Addenda No. 1

SUBJECT: US97: OR34 Hwy Jct – SCL Crescent Section  
The Dalles-California Highway  
Deschutes & Klamath Counties  
Grading, Paving and Signing Project  
(Bids to be opened and read April 23, 2009)

**The following changes are made to the Project Plans:**

- 1. Plan sheets 2, 2A-2, 2B-2 are replaced with revised plan sheets 2, 2A-2, 2B-2.

SHEET NO. 2

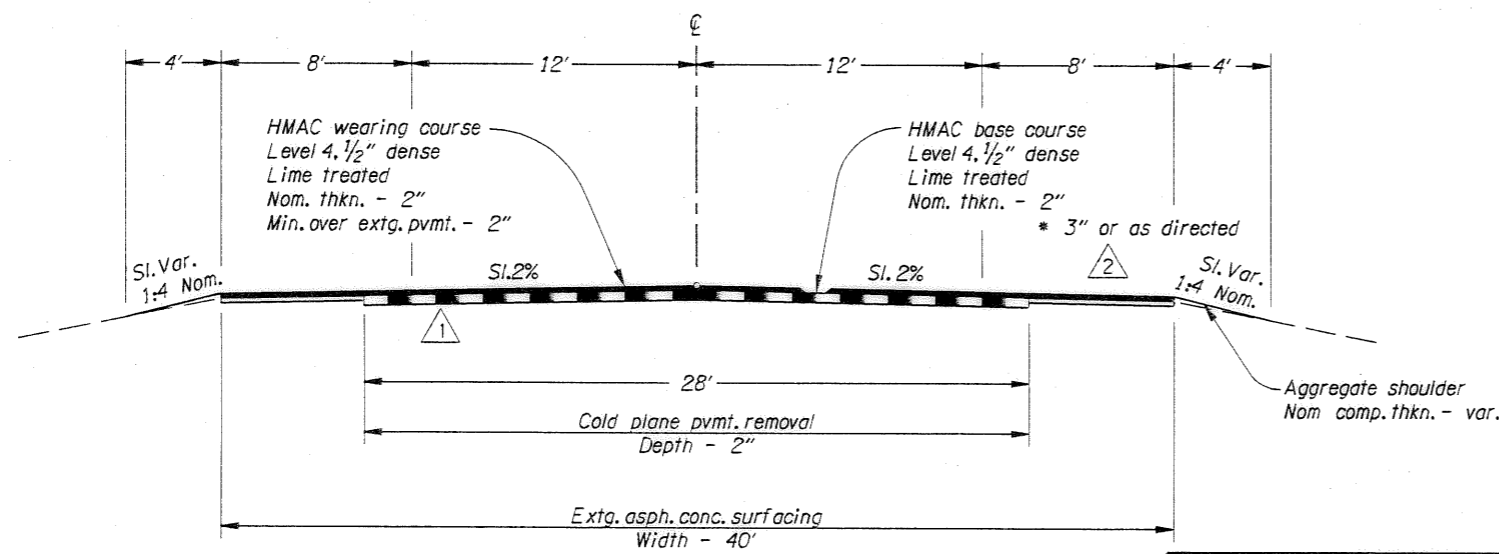
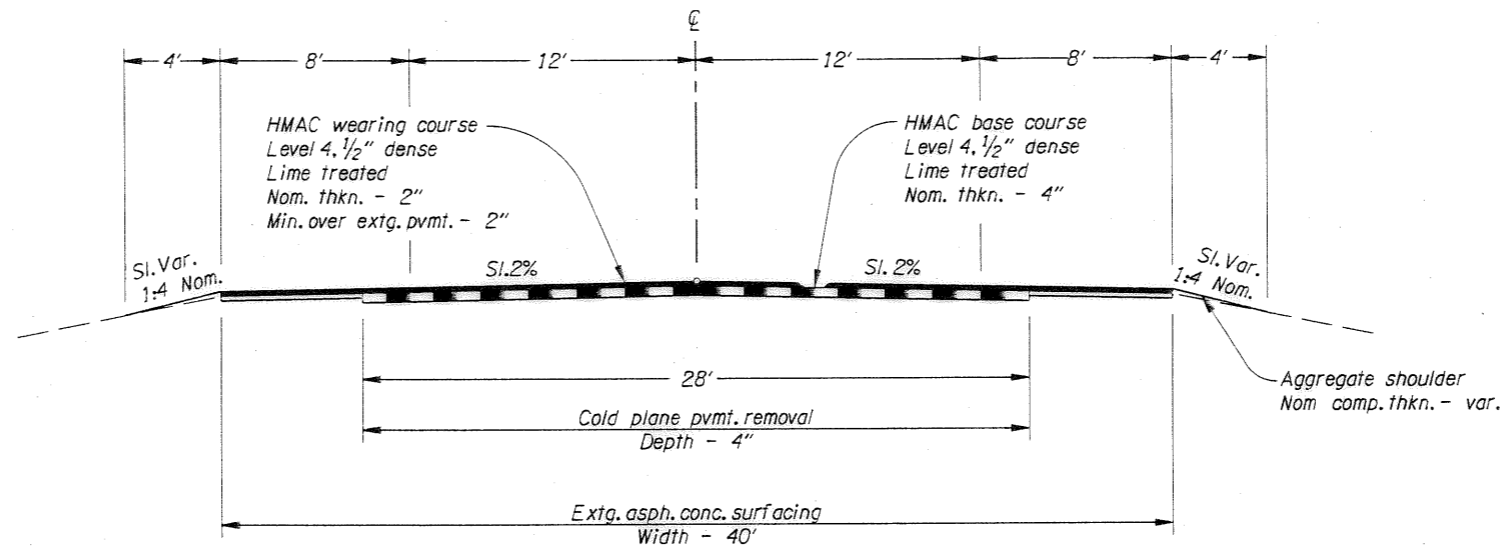
REVISIONS	
①	Revised 4-16-09 Removed HMAC leveling course
②	Revised 4-16-09 Revised thickness of HMAC base course

SHEET NO.  
**2A-2**

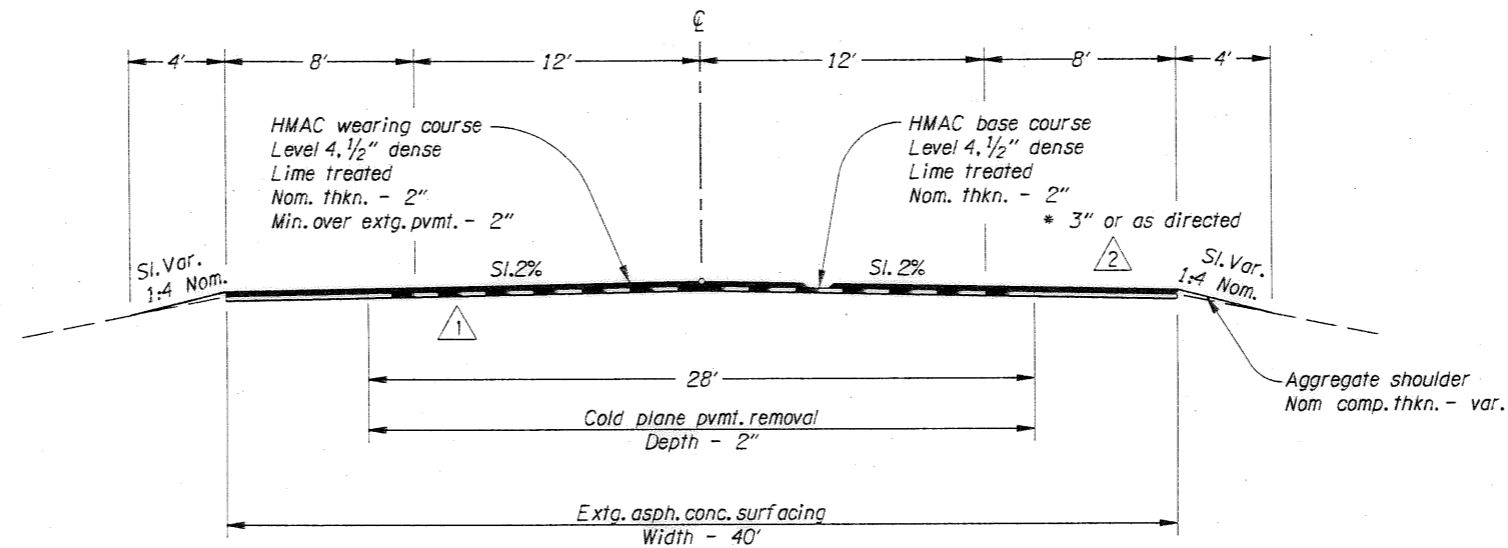
REVISIONS	
1	Revised 4-16-09 Removed HMAC leveling course
2	Revised 4-16-09 Revised thickness of HMAC base course

2B-2

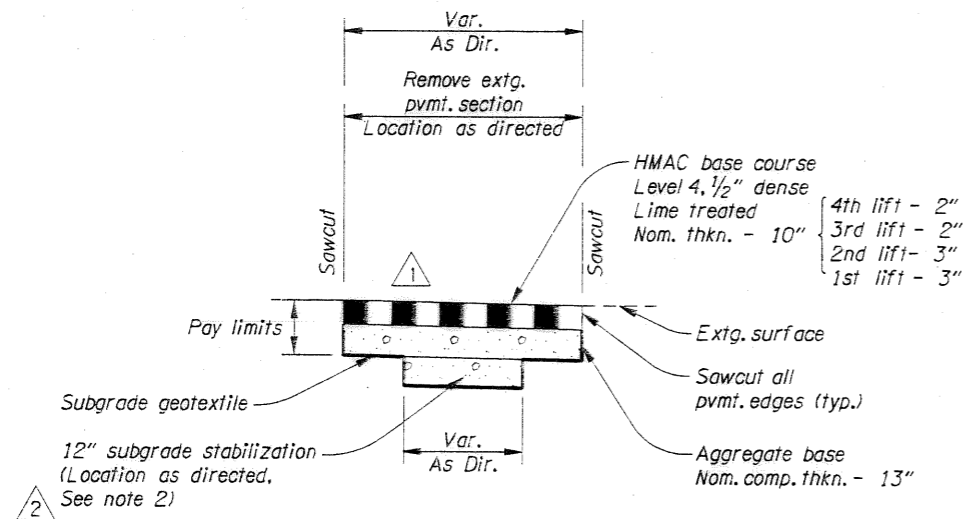
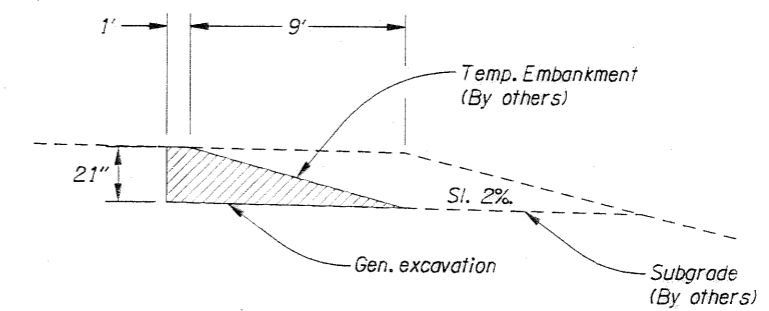
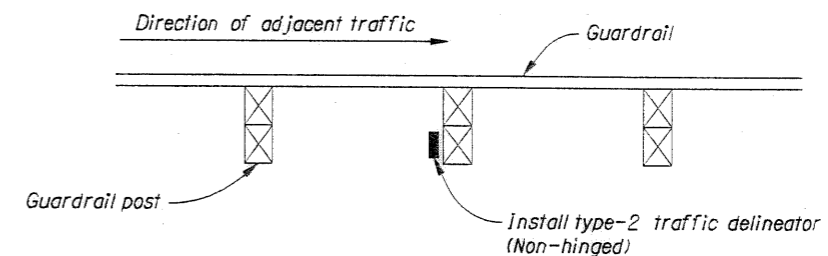
REVISIONS	
1	Revised 4-16-09 Deleted wearing course from detail
2	Revised 4-16-09 Added note
